DEVELOPMENT APPLICATION ASSESSMENT REPORT

Responsible Officer:	Phil Lane
Land to be developed (Address):	Lot 46 DP 6195, 1 Grandview Parade MONA VALE NSW 2103
Proposed Development:	Alterations and additions to a dwelling house
Zoning:	F4 Environmental Living

DA2021/1432

Eastern elevation (rear deck) with privacy screens

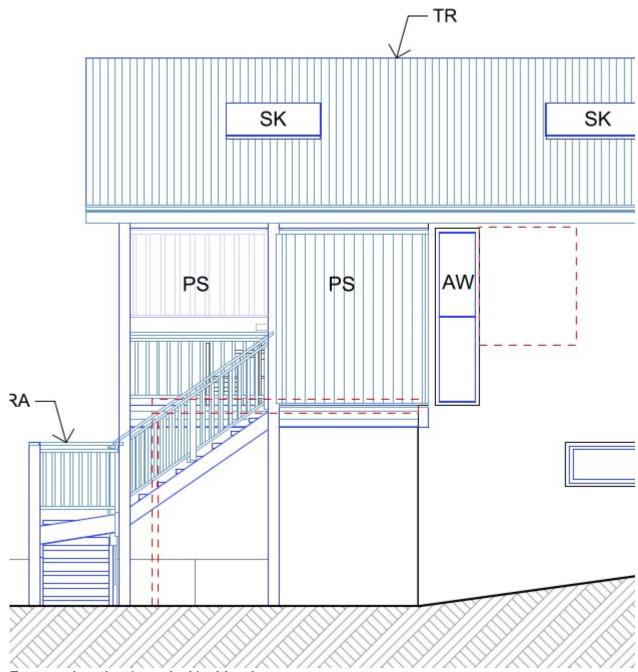
Comment: Issue was raised as follows:-

"The proposed first floor balcony would overlook the principle private open space currently enjoyed by my clients. Direct views should be restricted in accordance with the stated control. As proposed, the development would have an unacceptable level of harm on my client's visual privacy."

There is a ground floor deck to be constructed at the rear of the dwelling. A review of the plans demonstrates privacy screens to be fitted the eastern elevation of the deck which will ensure reasonable visual privacy to the adjoining property to the east (3 Grandview Parade).

Given the above it is considered that this issue does not warrant refusal and/or further amendment(s) via condition.
